Project Title: Stibnite Gold Project

Technical Memorandum

Subject: Stream Functional Assessment Scoring Concerns Addressed: Stibnite Gold Project

Date: May 20, 2019

Figure 1. Pool frequency for various CHaMP datasets and USFS dataset (Overton, 1995) separated by various channel wetted width.

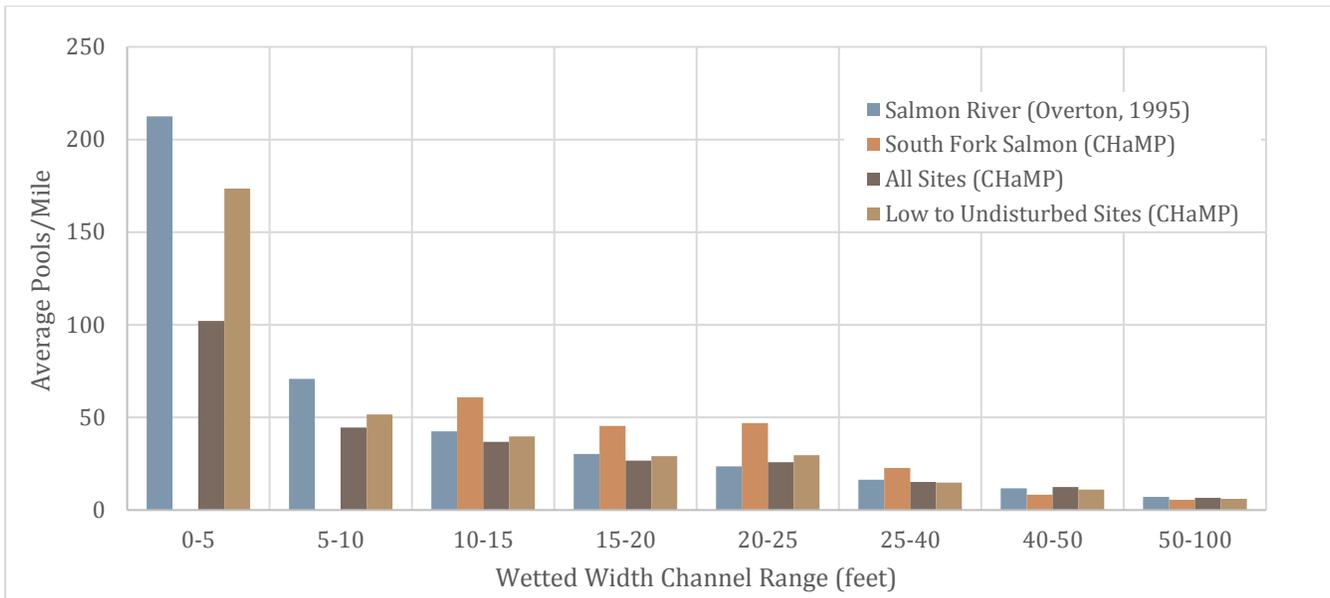
The issue with the current criteria is that the divisions between FA, FR and UR ($>$ 100% of average, 100%-67%, and $<$ 67%) were set arbitrarily and a more scientific/ statistically correct method has been requested to justify the scoring divisions.

calculated standard deviation for some of the wetted width categories exceeded the average pool frequency resulting in a negative or zero number of pools per mile. In addition, some of the sample sizes were so small that they did not provide an accurate representation of the specific wetted width size class (e.g. there were only two observations for the 0- to 5-foot wetted width classification).

As another comparison we also took the Salmon River pool frequency data (Overton et al 1995) and recalculated the data as an average number of wetted widths per pool (unitless dimension) for each size class and then combined all wetted width classes based on sample size to calculate the weighted average number of wetted widths per pool. This average number of wetted widths per pool was then converted back to number of pools per mile based on the specified wetted width groupings (Modified Overton Data). This creates a more robust data set (more sample sites) to develop an average unitless parameter scalable to different channel width classes. We compared these data to the various CHaMP data sets and all four of these analyses had similar distributions as seen in Figure 1 below.

As summarized in Figure 1, the modified Overton (1995) and CHaMP data collectively illustrate a similar relationship between pool frequency and stream wetted width. The large CHaMP dataset and the ability to query specific sites based on robust stream classification information, supports the selection of a dataset that is most representative of natural/reference conditions for streams similar to those at the SGP. As summarized in Table 1, **we recommend that the CHaMP dataset for “undisturbed” and “low disturbance” sites be utilized for analysis of total pool frequency.**
